67 FR 55280

INDIANA MICHIGAN POWER COMPANY
 Donald C. Cook Nuclear Plant
 1 Cook Place
 Bridgman, MI 49106
 616-466-2835
SHIPPING MEMORANDUM

Quantity	Item Description	Box Size	Weight
1	Radiological Surveys for Controlling Release of Solid Materials		6.15
			6.15
Total			Total

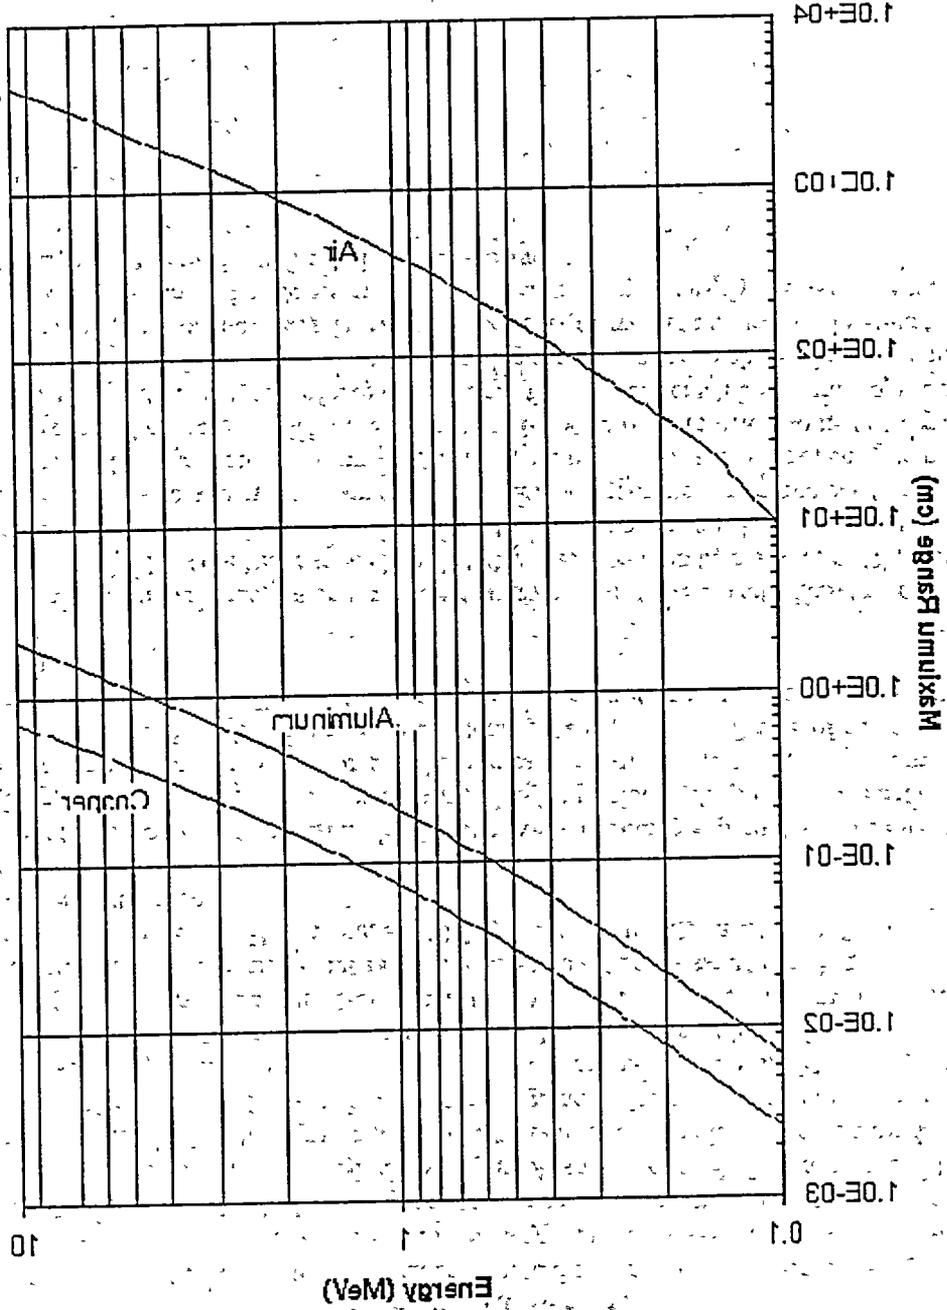
Nice backwards graph
